***REPORT ON AN ASSESSMENT OF
GRAND FALLS HOUSE
in
GRAND FALLS-WINDSOR, NEWFOUNDLAND
by
Rex Passion
for
Heritage Newfoundland and Labrador
on
June 18, 2025***

**Report submitted
July 31, 2025**

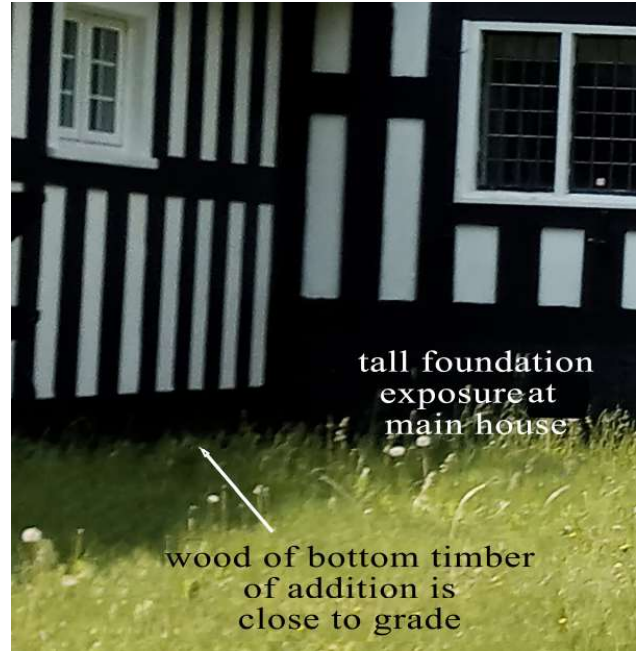
On the front elevation, at its tallest point, the concrete foundation is clad in field stone. Its height above grade on the left hand corner is 37 inches. The drip line at the foundation (where the water running off the roof hits the ground) is about 18 inches from the base of the foundation. The height of the foundation above grade and the large roof overhang prevent any splash from roof runoff contacting and damaging the wood.

37 inch exposure

33 inch exposure

25 inch exposure

17 inch exposure

The main house foundation is in excellent shape and needs no work. It is high-quality poured concrete with no evidence of cracking, spalling or other deterioration. It is being well preserved by being well painted.

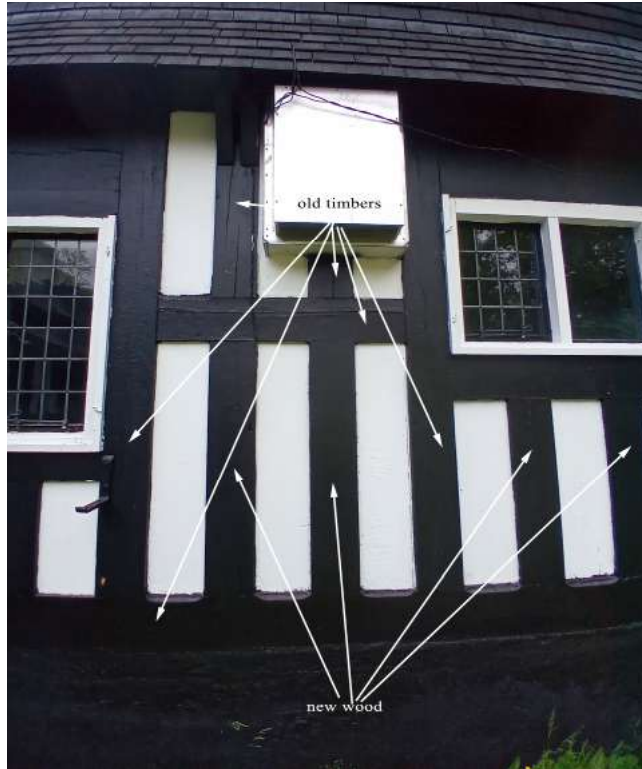
*I think this is an original wood
infill panel*

*In this one, there is
plywood over the original panel*

In the left front corner of the house, the wood infill panels appear to be original solid oak boards, but most of the other panels have been covered over recently with plywood or fiberboard. I have no idea of the original material or it's condition. Perhaps it is traditional wattle and daub (see below).

Historically the space between the timbers was filled with wooden lath and native plaster called wattle and daub or with brick. The fill on the front elevation below the left-hand windows appears to be the oldest and the material is wood. It is possible that this traditional wattle and daub filling might be covered with later wooden panels. Plywood and fiberboard were also used on top of the original fill. I would suggest one of the fiberboard panels be carefully removed to get a look at what may be the original filling material.

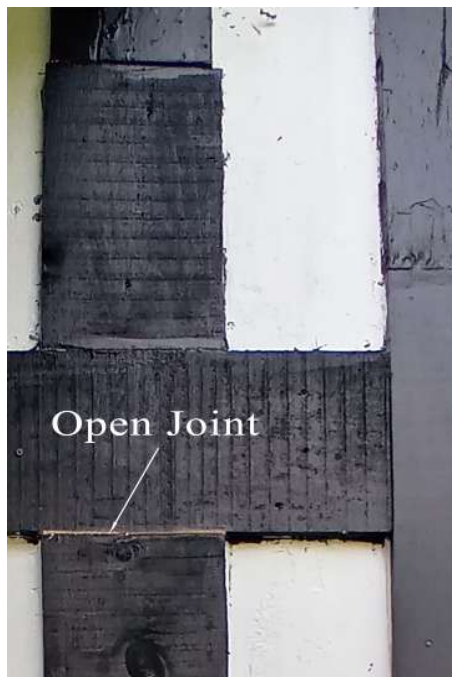
On the rear elevation, just northeast of the addition, some of the original oak timbers appear to have been repaired, or in some cases, replaced with modern, local wood, which is not as durable as the oak. Some of this repair work was done in a slipshod manner; other areas need to be repaired.

There is an open gap exposing raw wood which invites decay.

There are two small rot pockets in the timbers next to the window, nearest the addition

I believe prior to a 1980s renovation, some structural damage to the timbers on the back of the house was repaired, probably using modern lumber and framing. To keep the Tudor half-timber look of the building, smooth planed boards were used as faux timbers over the modern repairs. This accounts for the difference of the texture of the wood visible at the rear. Most of the repair work has been professionally done but some is slipshod resulting in some places where the wood is open to the weather. These need to be sealed to prevent damage.

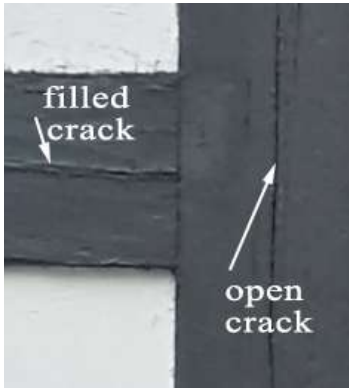
On the western end of the recess there is a plywood box concealing pipes, a chase. There is also one on the front elevation near the chimney and at the northwest corner. The front chase is filled with fiberglass insulation and I assume the others are as well.

In the frame of the center window on the left (northwest) end of the house there is a hole drilled for a cable. This hole should be filled with an appropriate material to seal out the water.

Center Chimney

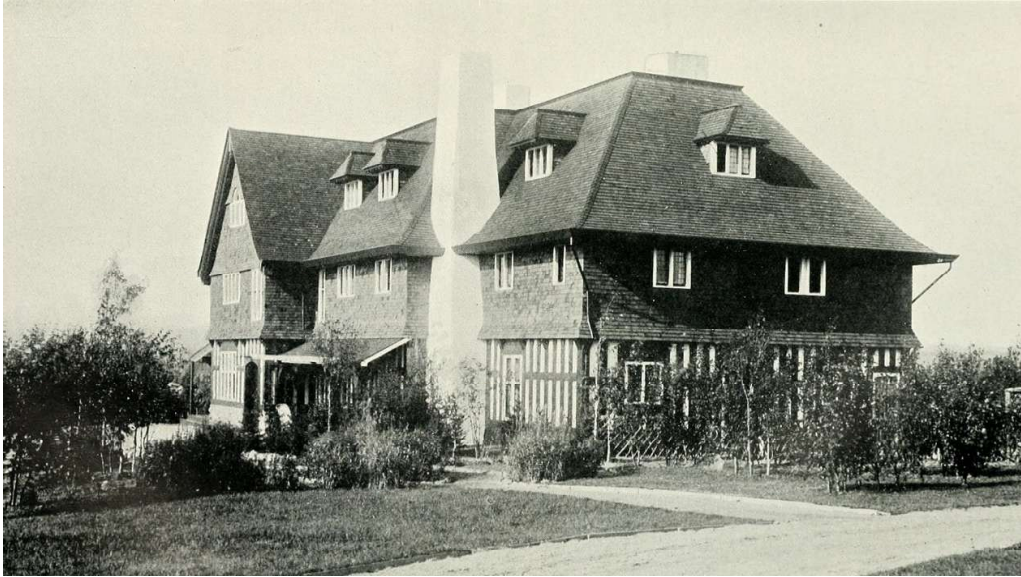
The center chimney was not visible from the ground.* It is sealed at the top and flashed to the very low-pitched torch on roof using standard flashing techniques.
